## **PLANNING AND ZONING COMMISSION REGULAR MEETING AGENDA**

WEDNESDAY, FEBRUARY 14, 2018

| 2. Consideration, discussion and possible action on a Concept Plan for 14870 Bois D'Arc Road, twenty (20) lots on 20.02 acres more or less located at 14870 Bois D'Arc Road. Owner: L4S, LLC. Applicant: Southwest Engineers, Inc.                                                    | Scott Dunlop<br>Planning Coordinator |

| 5. Consideration, discussion, and possible action upon a Preliminary Plan for Manor Heights Phases 1-2, two hundred sixty-four (264) single-family lots on 127.22 acres more or less, located Bois D’Arc Road and Tower Road.                                                                                                                                                                                                                                                                                                                                                                                                                               | Scott Dunlop,<br>Planning Coordinator |

BOIS D' ARC SUBDIVISION  
CONCEPT PLAN

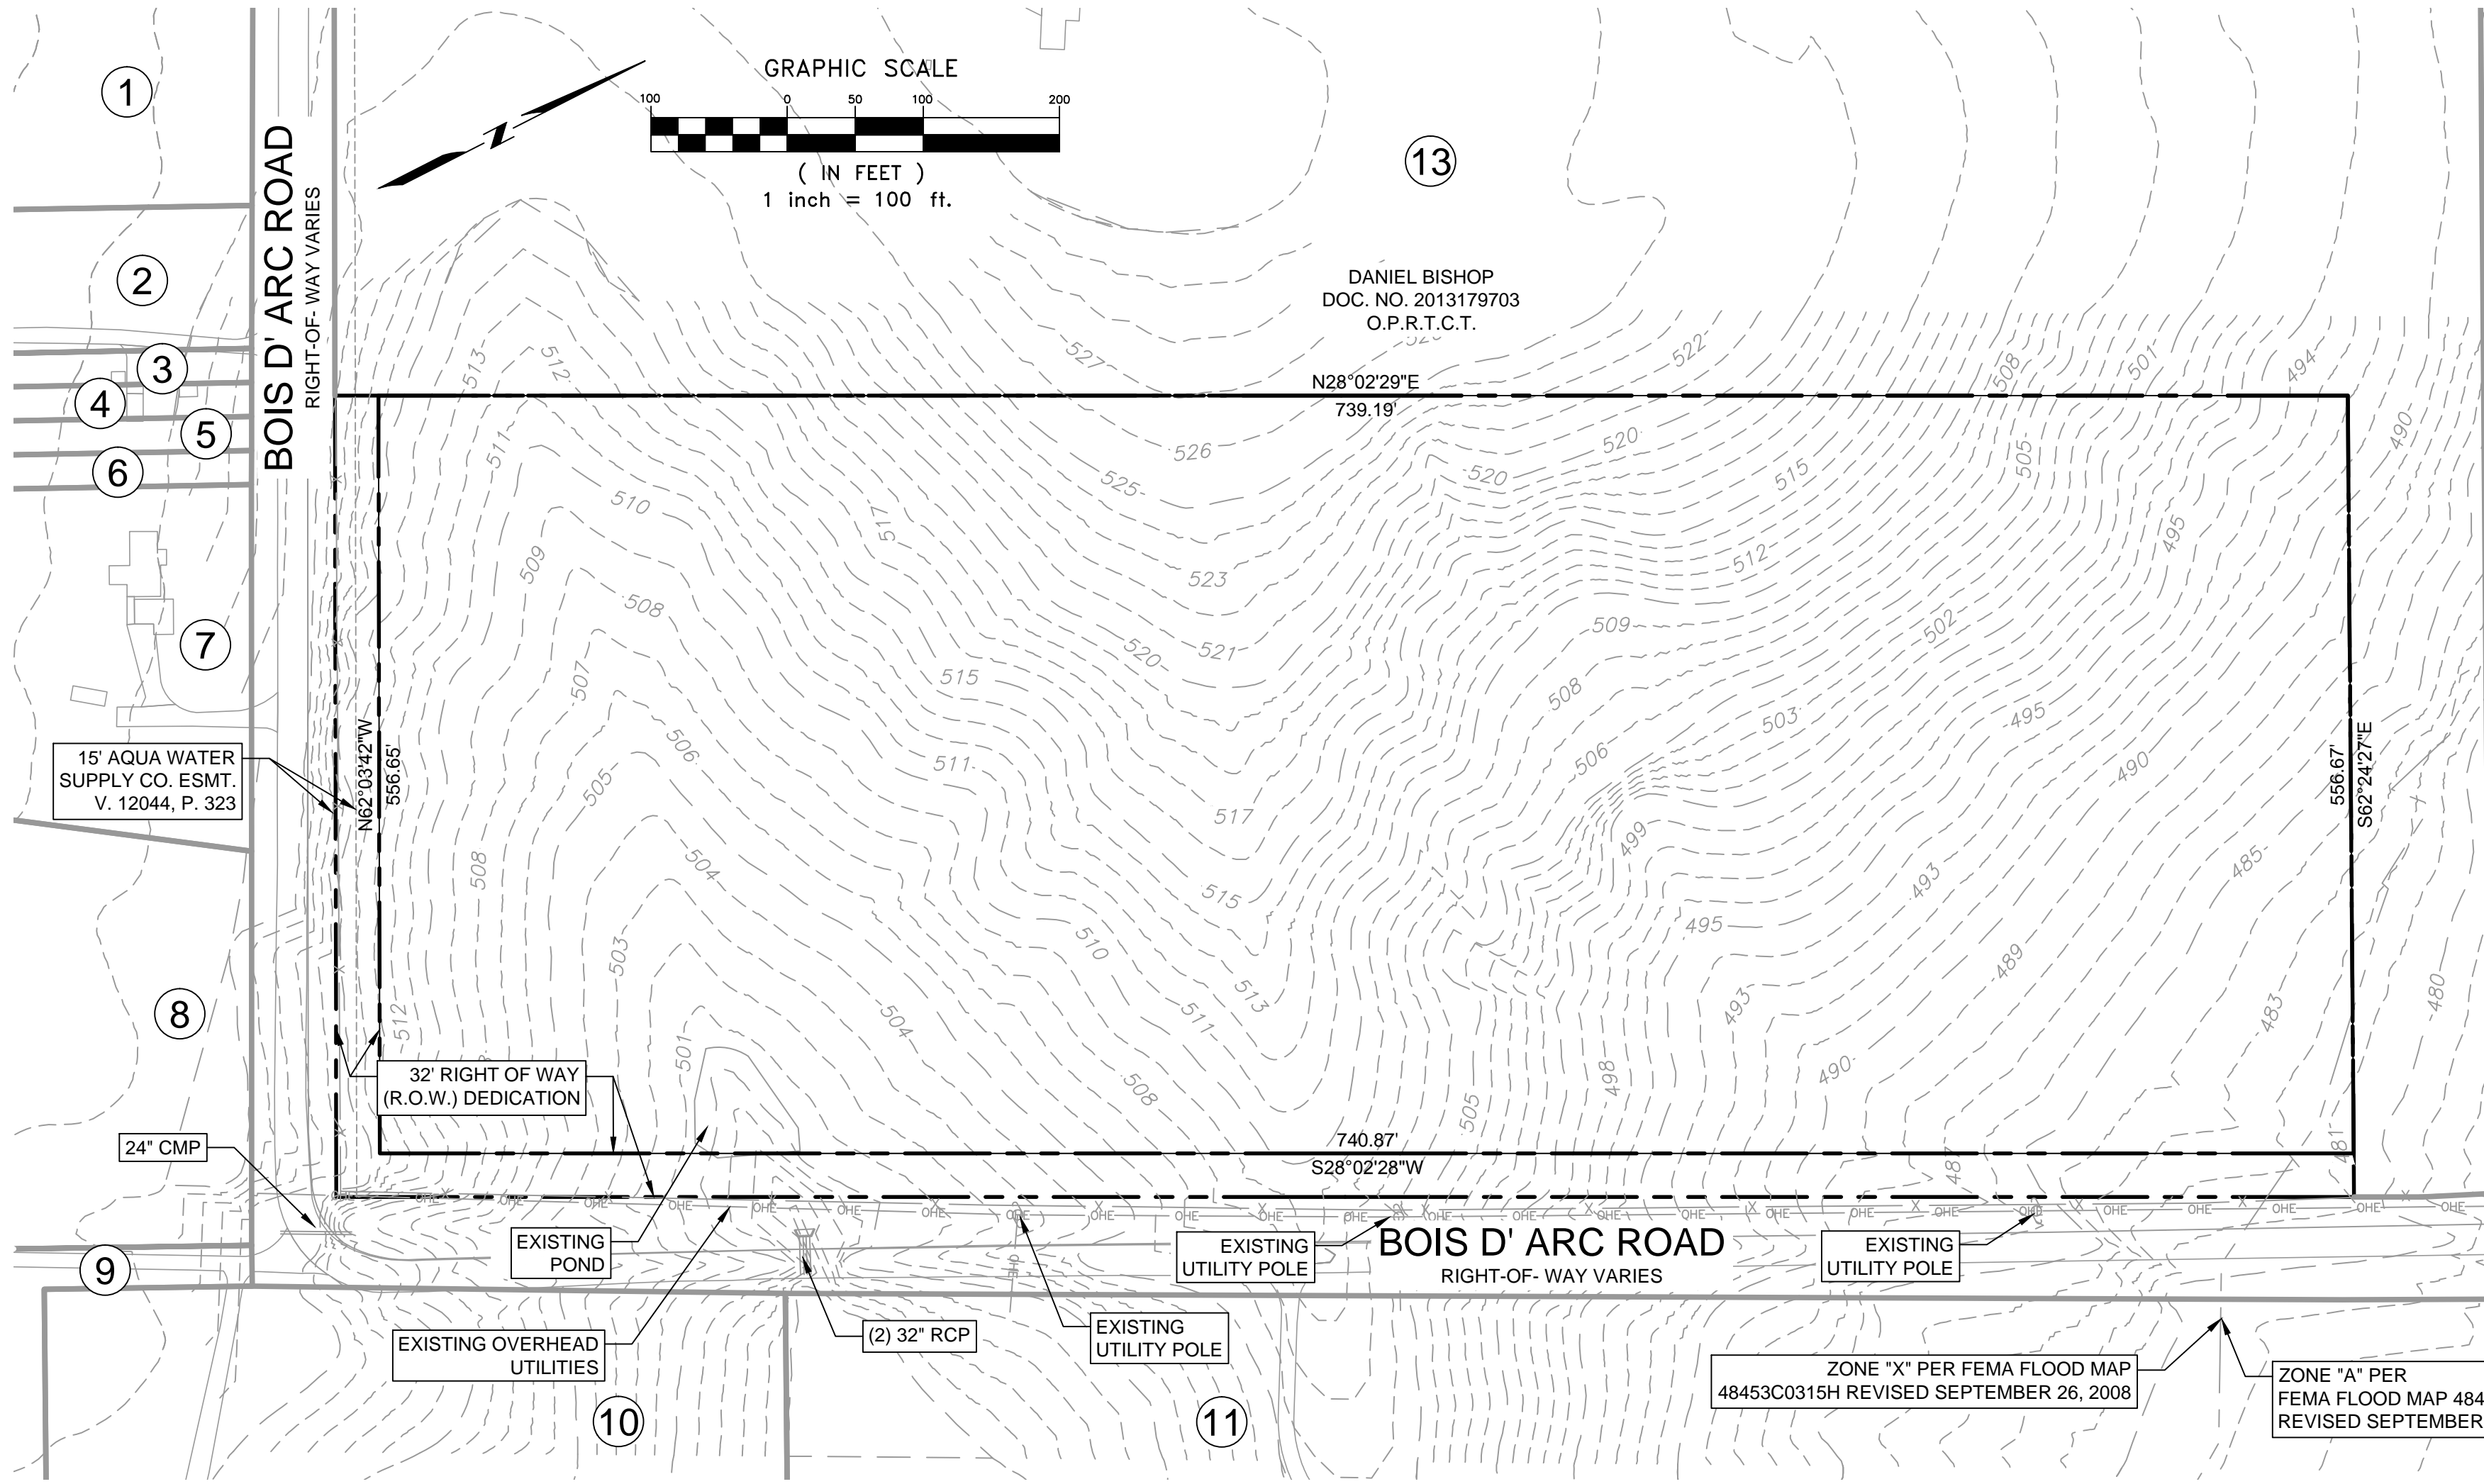
**2. Per Section 42(f) of Subdivision Ordinance 263B, a developer is responsible for dedicating additional right-of-way that is required for the streets and roads adjacent to and abutting the boundaries of the Subdivision. The required right-of-way dedication is thirty-two (32) feet for lots located along Bois D'arc Road. This dedication is required to be shown on the Concept Plan.**

**3. At this point in the development review process, individual lot lines are not required to be shown on the Concept Plan and should be removed.**

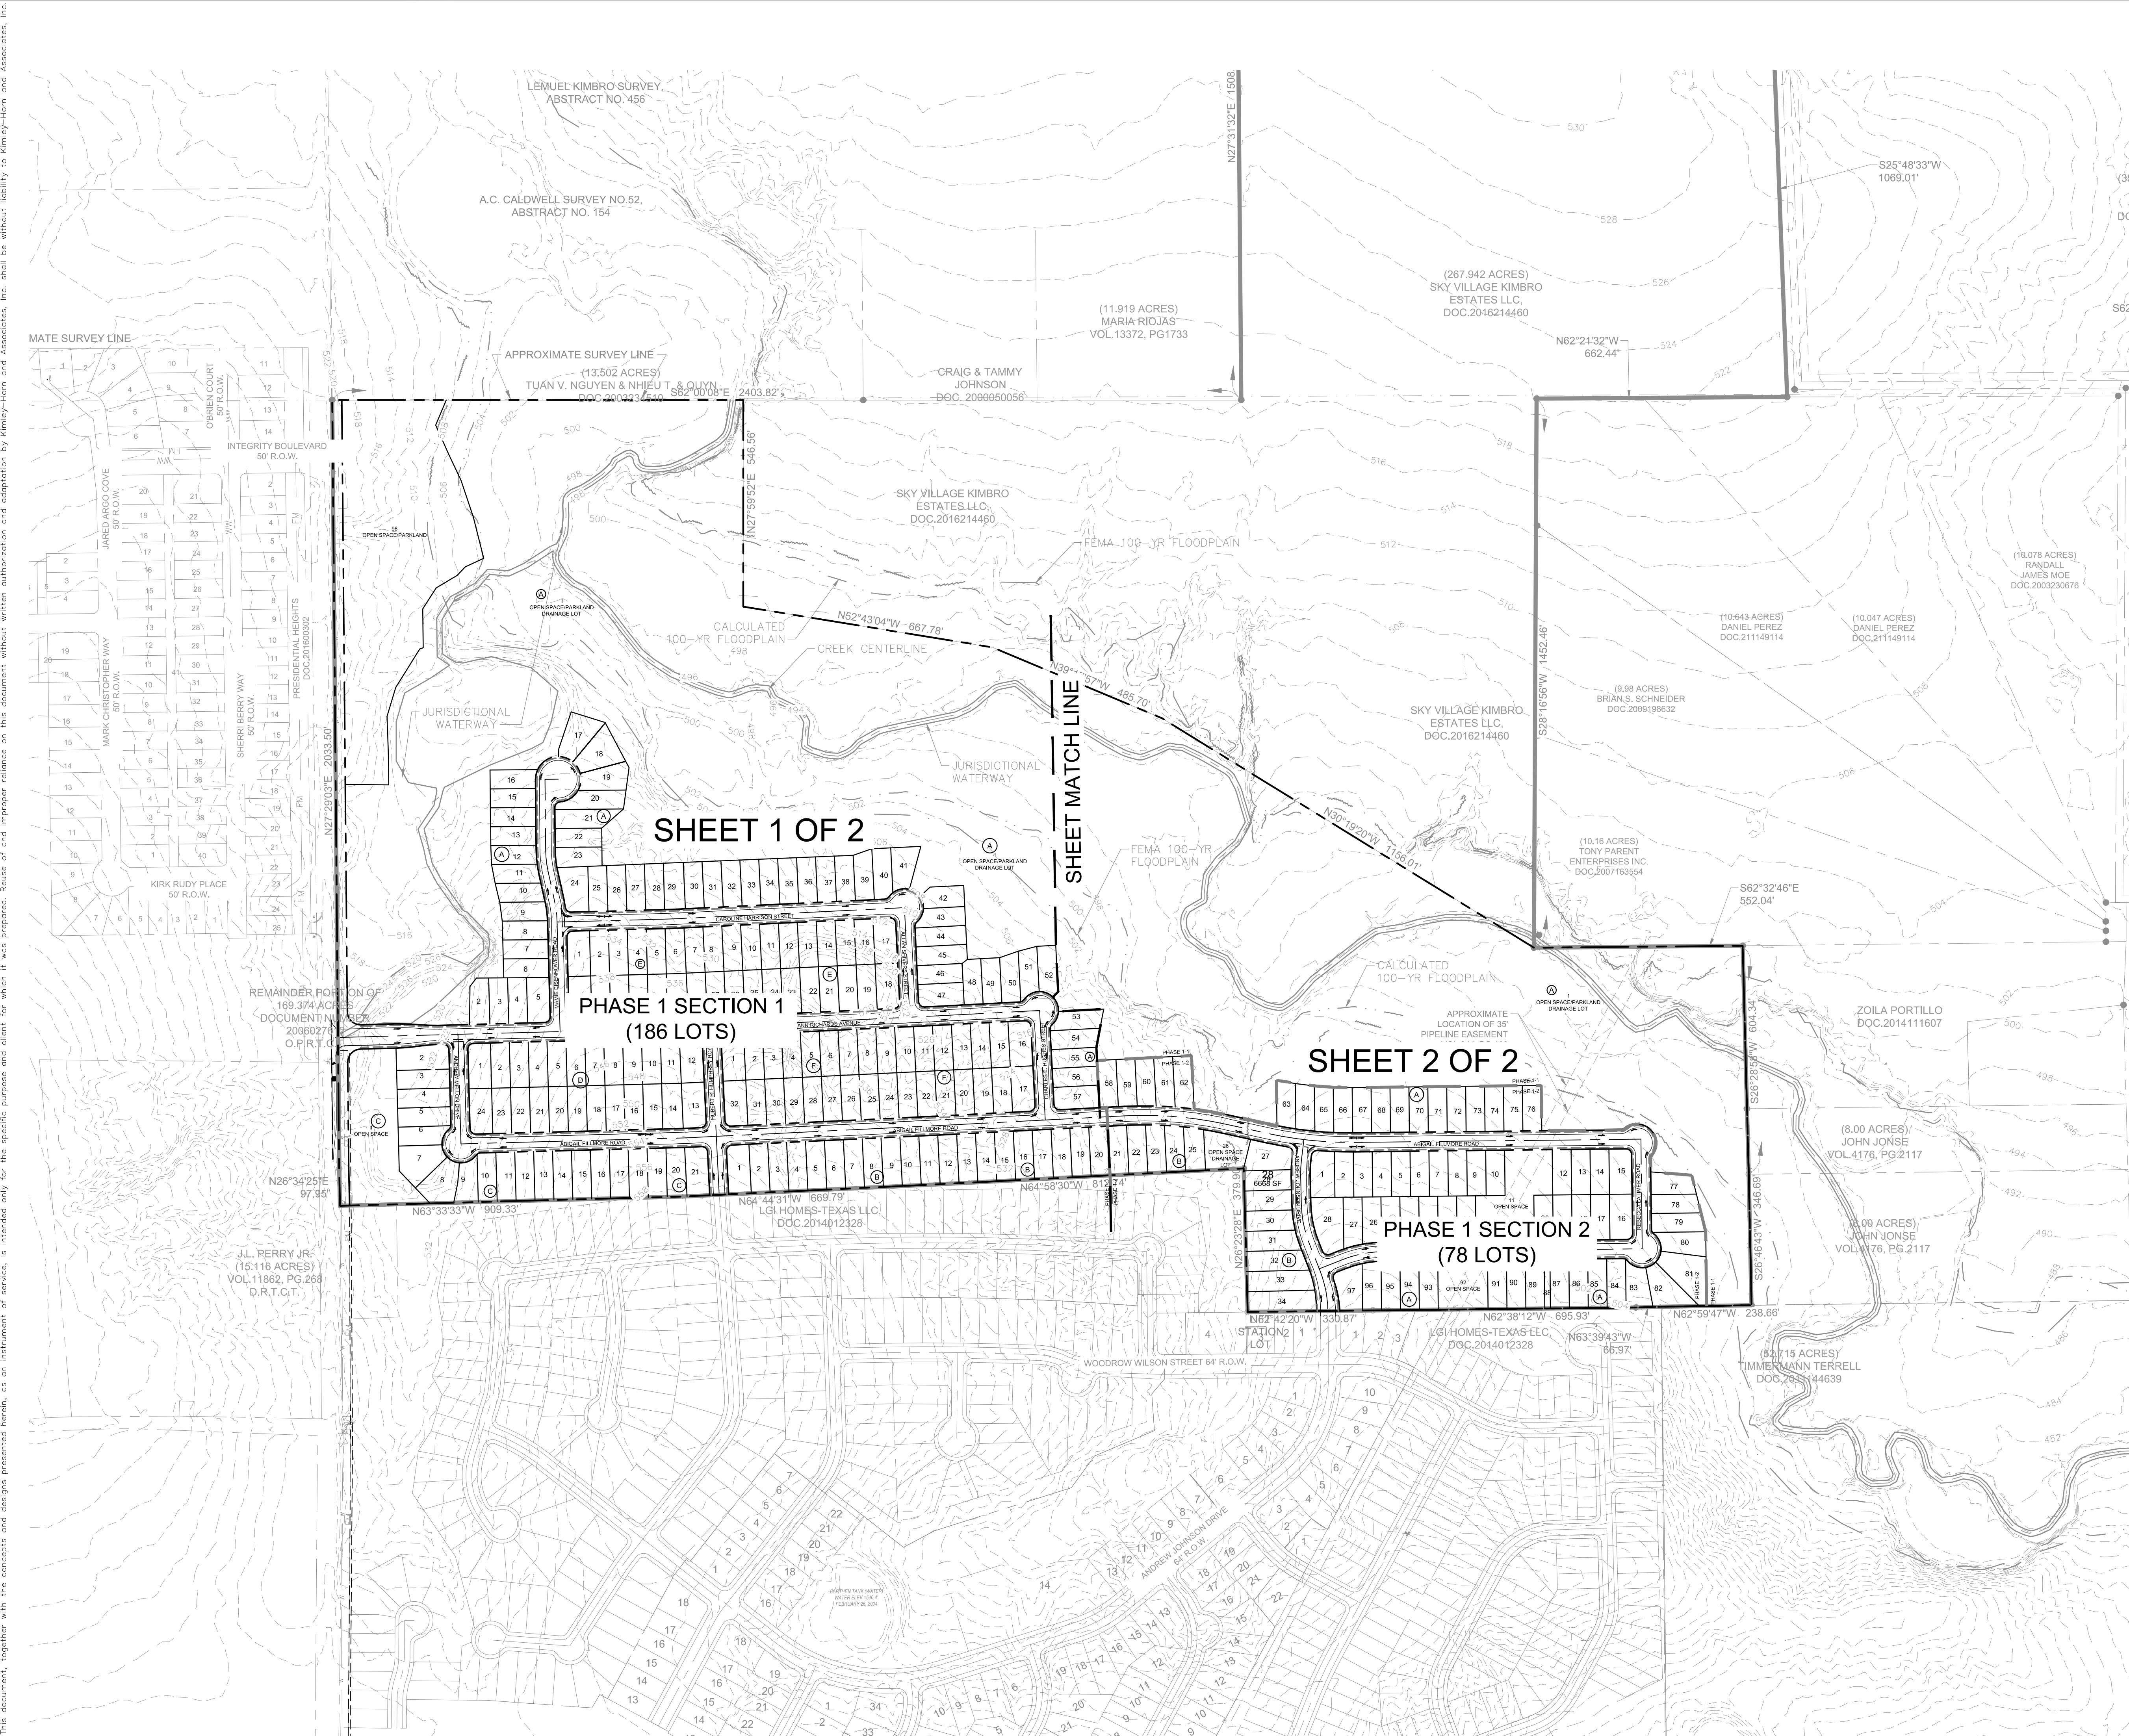
1. Section 22(a) of Subdivision Ordinance 263B requires that a Concept Plan be approved prior to approval of the preliminary plat.
2. On Sheet 2 both Phases are labeled Phase 1.

4. Section 22(c)(3)(viii) of Subdivision Ordinance 263B requires that replacement trees be shown on the Preliminary Plat based on the ratio of 1:2 for Significant Trees larger than 18 inches and 1:1 for Significant Trees between 8 and 18 inches. Also, there are trees listed on Sheet 7 to be removed, but no replacement calculations are provided.

5. The floodplain should be clearly delineated as required by Section 22(c)(2)(v) of Subdivision Ordinance 263B.
6. Section 22(c)(2)(vi) of Subdivision Ordinance 263B requires that topography be shown. Additional labels should be added to the topography.

7. Sheet 6 shows the proposed wastewater line tying in to an existing line on Lot 1 Block A. The existing wastewater line should be shown. Section 22(c)(2)(vii) of Subdivision Ordinance 263B requires that the locations, sizes and descriptions of all existing utilities, including but limited to wastewater lines, lift stations, wastewater manholes, waterlines within the subdivision and/or adjacent thereto. The existing lift station should be shown on Sheet 7.

8. The Jurisdictional Waterway should be clearly shown on Sheet 10 near the proposed 8'x4' box culvert on Harry S. Truman Street.

10. Roadway intersections should meet at a 90 degree angle.
11. On Sheet 4 no right of way width is listed for George Washington Drive. On Sheet 5 no right of way width was listed for Andrew Johnson Drive. Section 22(c)(3)(iii) of Subdivision Ordinance 263B requires that the dimensions of all proposed streets be shown on the preliminary plan.

14. The Engineer's Report states that a bottomless culvert will be constructed under Street J. Clarification should be made as to what street this is on the plans.

15. The Flood Insurance Rate Map in the Engineer's Report does not show the proposed project's location.
16. The Engineer's Report states that offsite flow from Presidential Meadows impacts the site. This should be verified.

**Response: A Development agreement with exhibits that include an approved concept plan have been submitted to the Jay Engineering for review with this resubmittal.**

**Response: Sheet 2 has been updated to show Phase 1-1 and Phase 1-2.**

**Response: Calculations for tree removal and associated mitigation have been updated with this submittal.**

**Response: Additional floodplain labels have been added to clearly delineate the floodplain.**

**Response: Topography labels have been added to clearly show topography.**

viii. **Response: The label showing the proposed wastewater line tying into the existing line on Lot 1 Block A has been updated to show the proposed wastewater line ending with a 4-foot manhole and 12" stub, there is no existing wastewater line at this point.**

**Response: Jurisdictional Waterway label added on sheet 10 to clearly show the jurisdictional waterway near the proposed 8'x4' box culvert, please note that Harry S. Truman Street is now Ann Richards Avenue.**

**Response: All roadways have been checked to connect at a 90-degree angle. Previously the intersection of Andrew Johnson and Ronald Reagan Avenue was slightly skewed, it has been revised to connect at a 90-degree angle.**

**Response: Right of way width labels are now provided on all streets.**

**Response: Street names are updated throughout the plans and engineers report.**

**Response: Map has been updated to show project's location.**
